**WHITE LAKE TOWNSHIP
PLANNING COMMISSION**
7525 Highland Road
White Lake, MI 48383
JANUARY 7, 2021 @ 7:00 p.m.
Electronic Meeting

RE: Eagles Landing - Final Site Plan and Final Engineering Plan Review- 3rd Review

Subject: Eagle Landing Project
Final Site Plan Review #2

RE: Pontiac Lake Overlook (FKA Pontiac Lakeview Apartments)- Preliminary Site Plan Review – 3rd Review

Title:
LANDSCAPE PLANTING PLAN

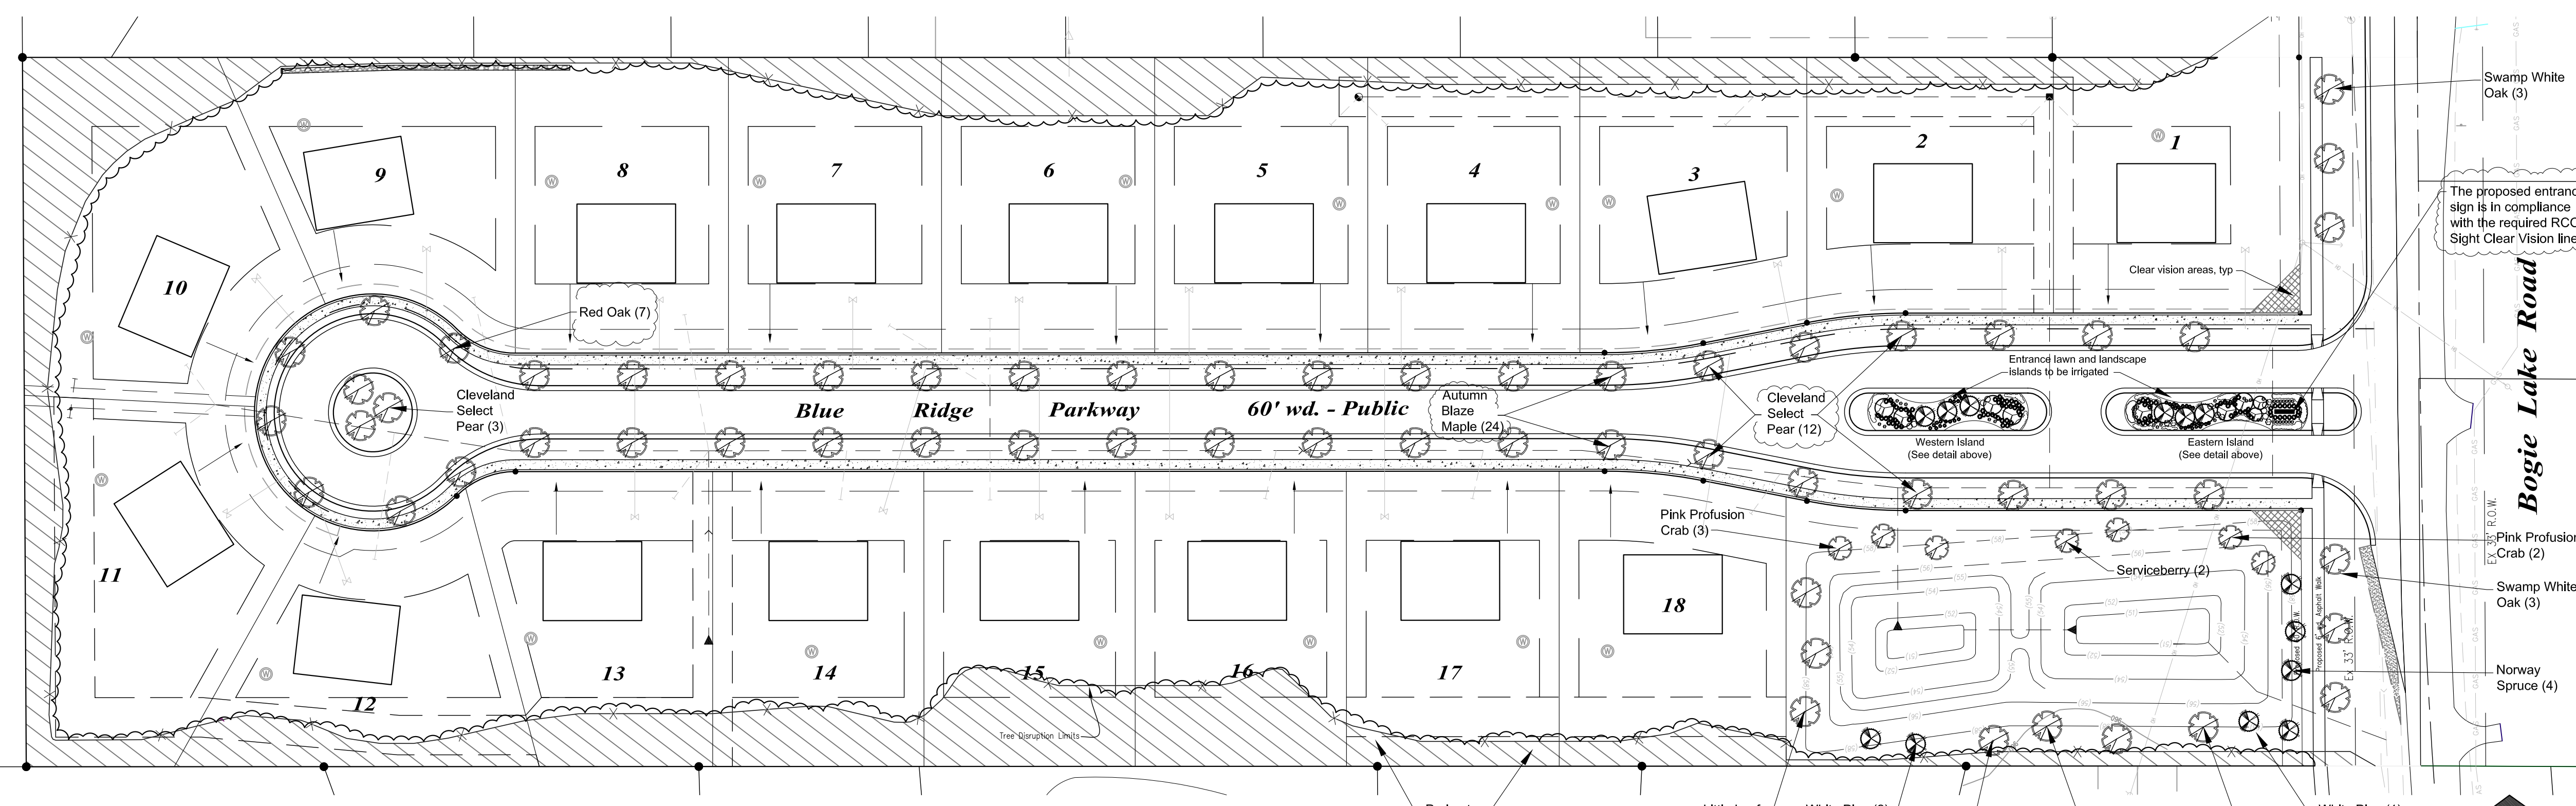
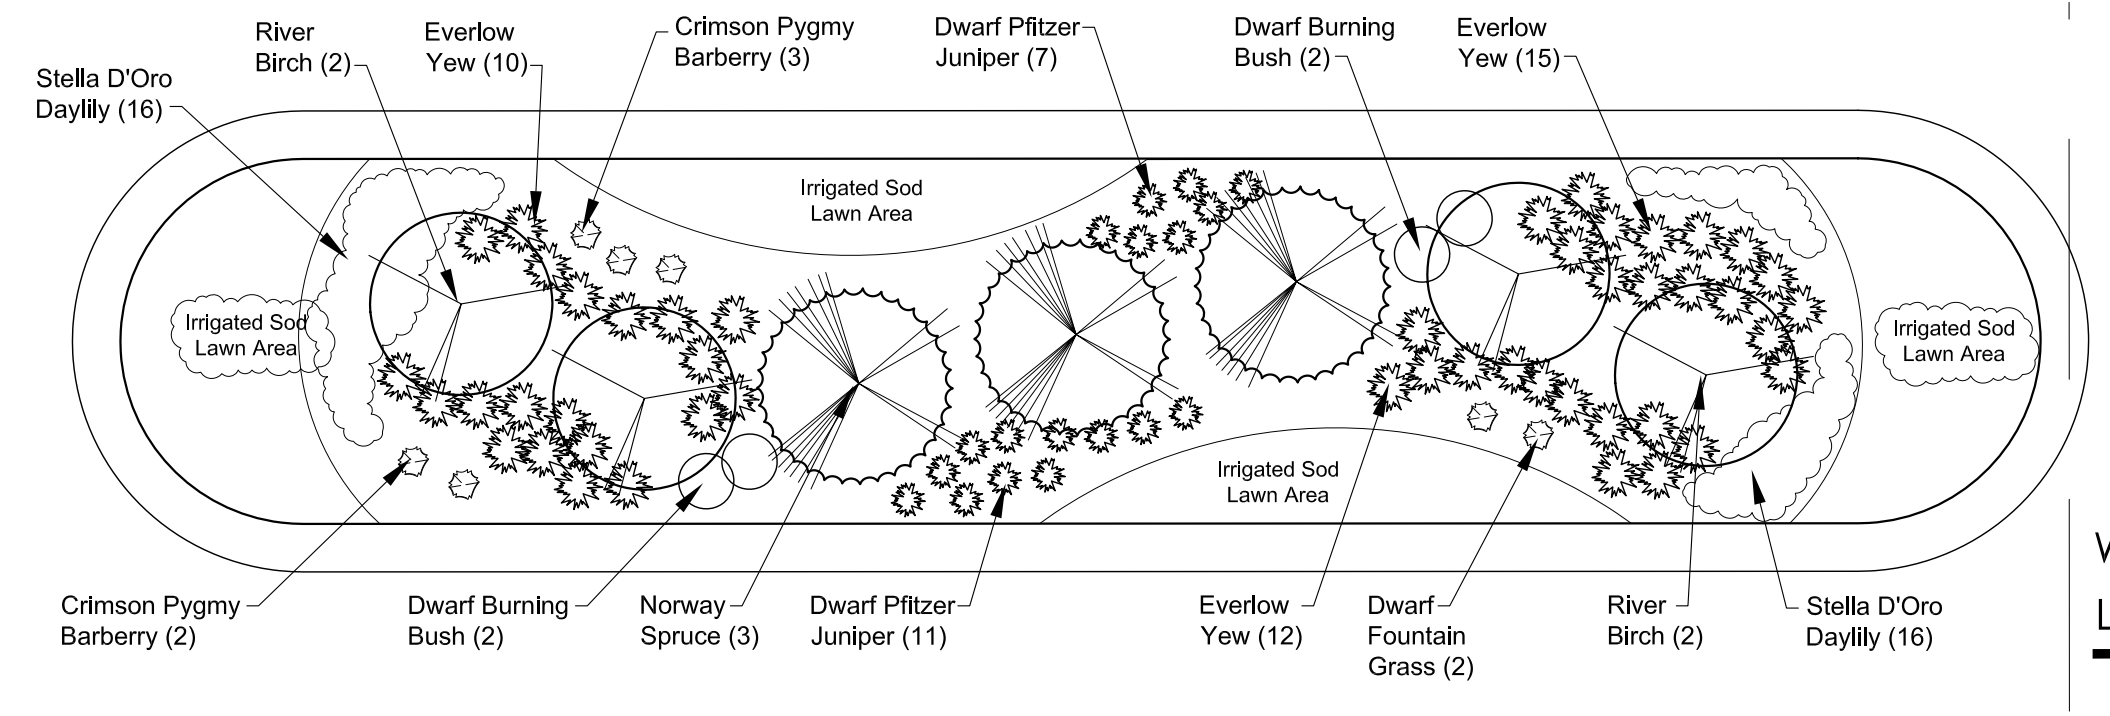
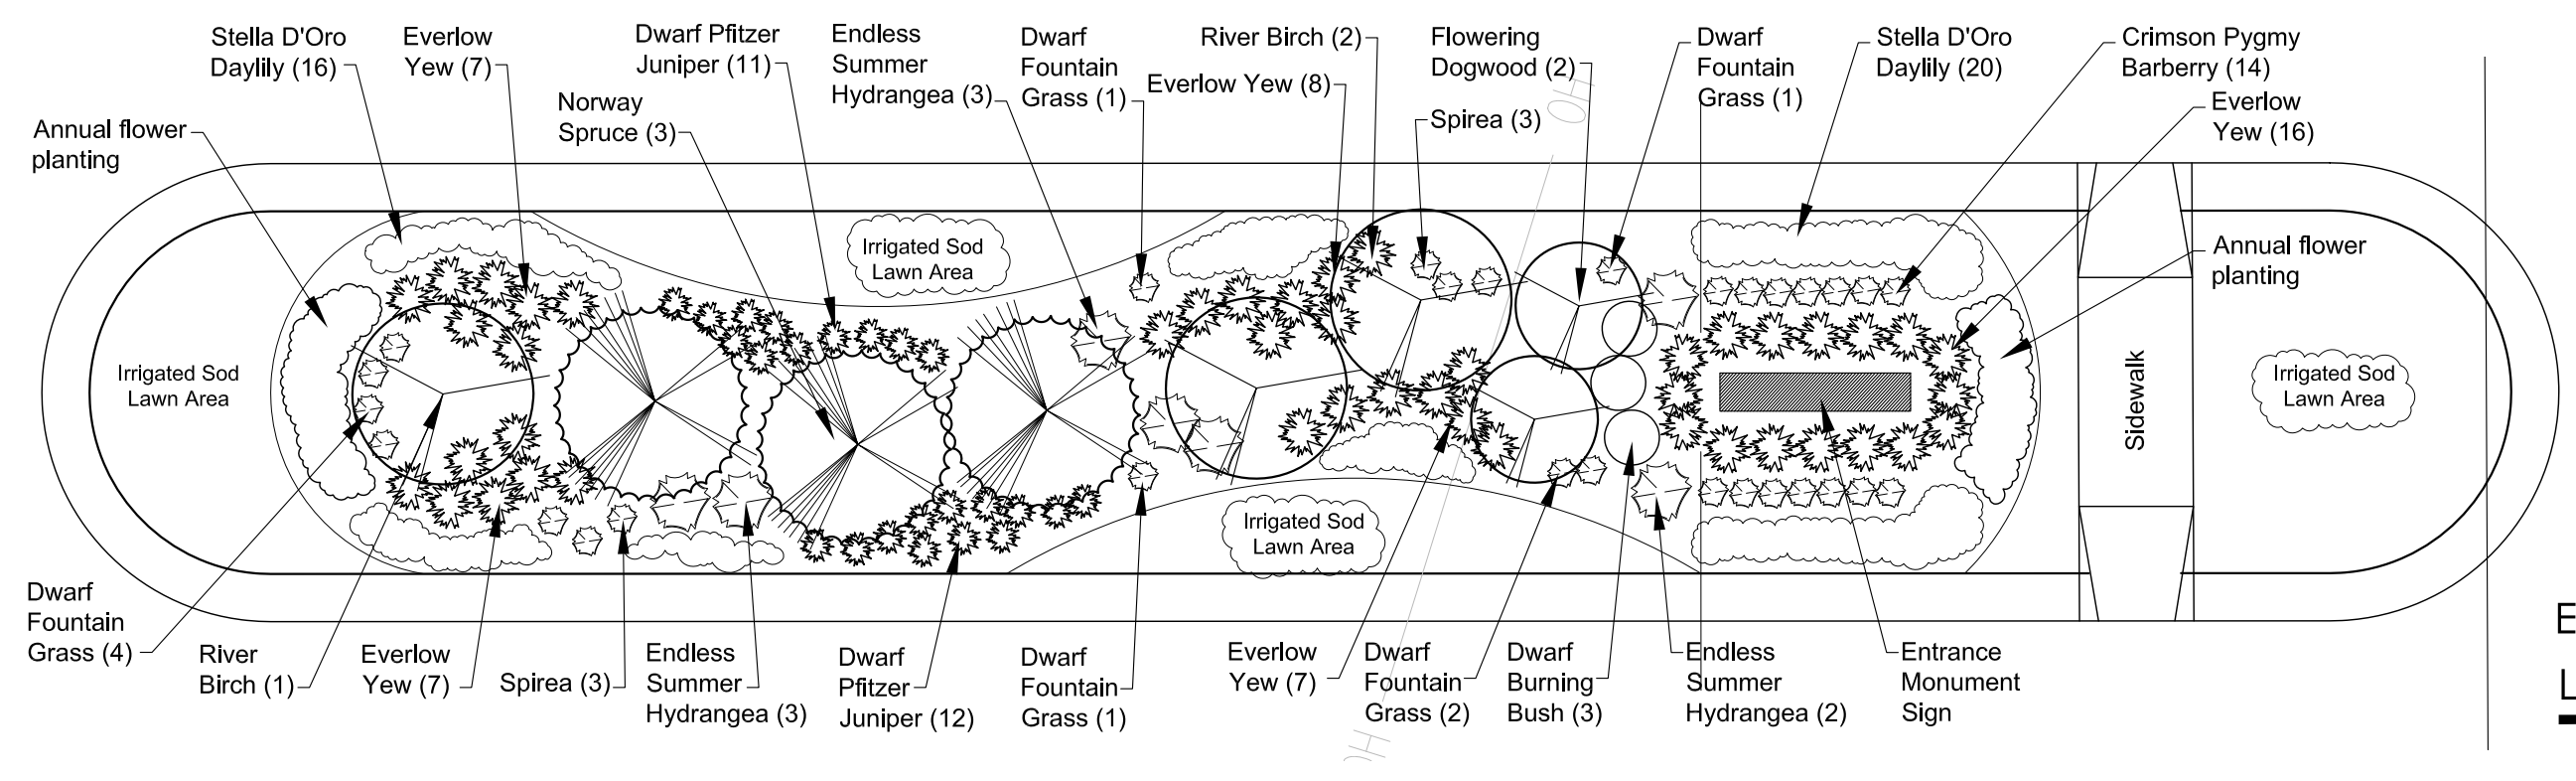
1. *The Landscape Plan shall show locations of all proposed storm sewer and sanitary sewer. Trees cannot be planted over or within 10' of sanitary sewer or storm sewer. Additionally, plantings of any type cannot be planted within surface drainage areas such as swales. There are several areas as follows on Sheet LP-1 where there are conflicts as listed: 1) Trees along the south side of Blue Ridge Parkway and in center of cul de sac are proposed over storm sewer 2) Tree over detention basin outlet pipe 3) Two northernmost trees along Bogie Lake Road frontage over/in ditch line and storm sewer . (Reference General – Comment 2 of our Preliminary Site Plan Review letter dated June 26, 2019 as well.) Comment outstanding. Design engineer indicates that Sheet LP-1 is to be revised by Landscape Architect. Sheet LP-1 was not included in this submittal and will need to be included with next submittal. **Comment partially addressed. Please update Sheet LP-1 to reflect revisions to storm sewer per engineering plans. (Ex. There is no storm sewer now between Units 13 and 14). In addition, please relocate proposed tree that is in middle of the cul-de-sac; it is proposed directly over the storm sewer.***

Applicable Requirement	Landscaping Requirements	Proposed Landscaping
Section 5.19(A)(iii)	All landscaped areas greater than 200 square feet must be irrigated.	An automated irrigation is noted in number 19 of "Planting Notes" on the Landscaping Sheet.
Section 5.19(F)	<p>150 lineal feet of entry drive shall be landscaped, including 1 tree and 3 shrubs for every 300 square feet of landscape area.</p> <p>Calculations are not available for the area of landscaping but based on approximately 200 linear feet in length and 20 feet in width, there should be 14 trees and 42 shrubs.</p>	<p>The first 220 feet are landscaped, with a 20-foot gap for a turnaround drive.</p> <p>There are 6 Norway Spruce, 6 River Birch, and 2 Flowering Dogwood proposed, and the number of shrubs far exceeds the minimum requirement.</p>
Section 5.19(F)(iii)(d)	Landscaping must adhere to clear vision standards.	<p>The proposed landscape plantings will comply with the clearance standards because they are low-growing species.</p> <p>The proposed entry sign may conflict with clear vision for vehicles exiting the site. Clearance lines in the median have been confirmed on the revised landscaping sheet.</p>
